To: MEMBERS OF THE PLANNING AND ZONING COMMISSION
RE: REGULAR MEETING – **WEDNESDAY, MAY 20, 2026**

1. **2135, 2145 & 2155 Reservoir Avenue:** Applicant, Vessel RE Holdings, LLC, is requesting reconsideration of their previously denied application for a Site Plan Approval of a multifamily housing development containing 150 units, pursuant to Sec 8-30g(h) of the Connecticut General Statutes. **File #26-10** ***Continued from April 22, 2026***

Re: Resubmission Pursuant to CGS §8-30g(h)
Site Plan Application at 2135, 2145 & 2155 Reservoir Avenue

Based on the review of the proposed Site Plans and Drainage Report, submitted on 11/13/2025, the Engineering Department offers the following comments (**please provide written responses in the space below**):

Sheet #: 2.31

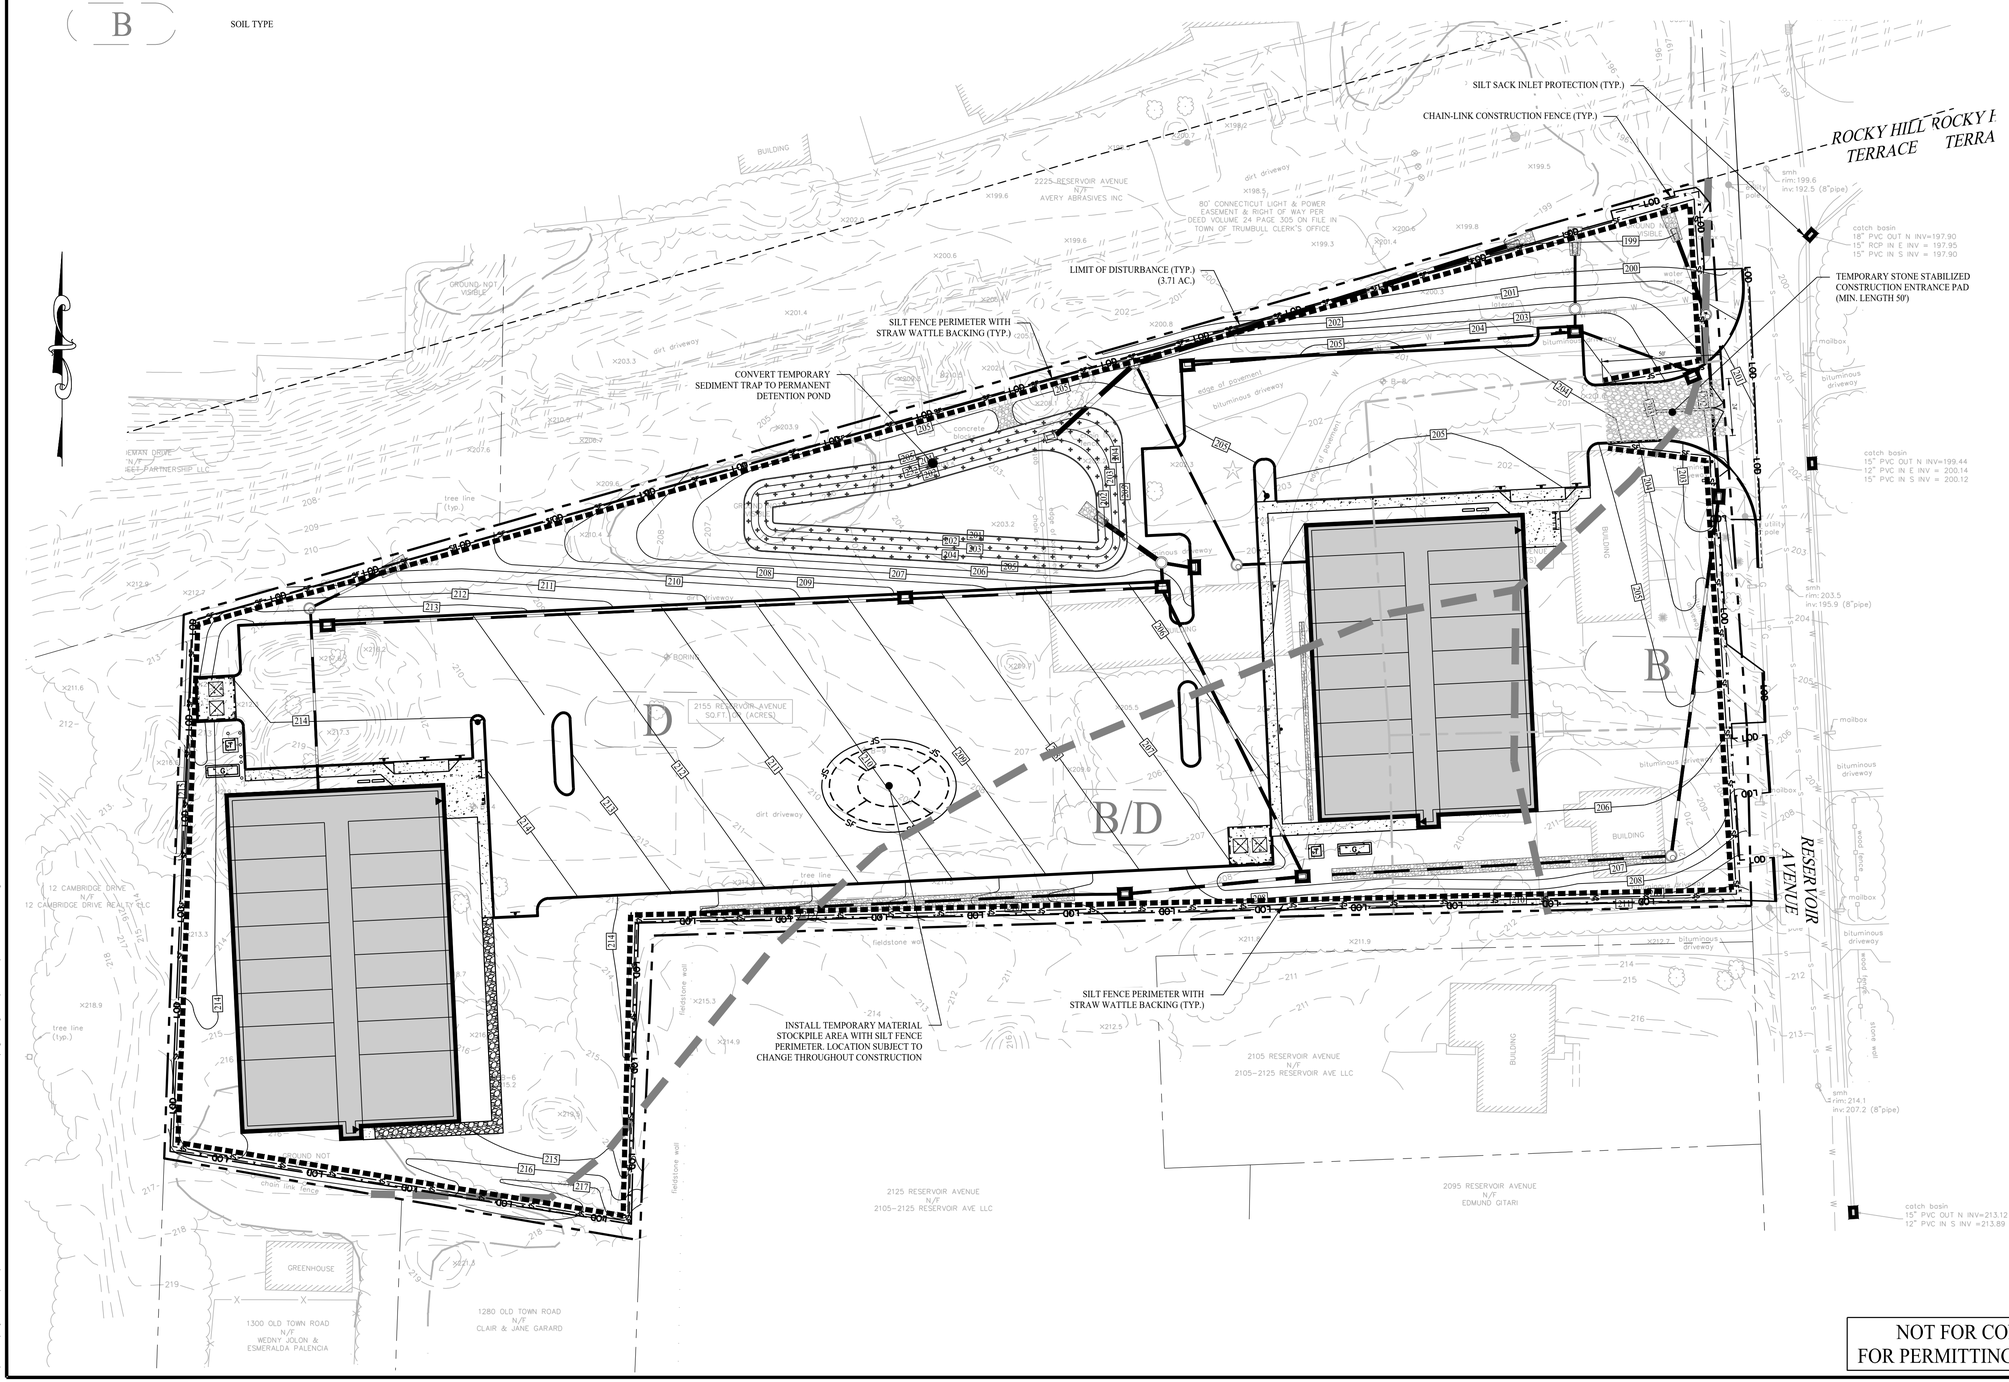
Comment Number	Page or Sheet #	Review Comments – General Comments	Designer Response
9		Please provide a cross-section through the pond that details the proposed embankment material. Additionally, ensure that the materials selected are suitable for preventing erosion, seepage and are designed to withstand the potential impacts of weather conditions.	A cross-section through the pond showing the enbankment material is provided on Sheet 2.21.
10		Please label maintenance access.	Maintenance access at 1:6 slope is shown for the detention pond and labeled on Sheet 2.21
11	Site Plan	Add note indicating that all pipes under the driveway / parking lot are H-20 rated.	A note has been added to Sheet 2.21
12	Site Plan	If proposed, depict footing drains on the plan.	If required, footing drain locations will be shown on a revised Sheet 2.21 for review prior to construction.
13	Erosion Control Plan	Concrete washout location & detail must be shown on the plans.	A concrete wash rack has been added to the construction entrance on Sheet 2.31. Please see detail on Sheet 2.41.
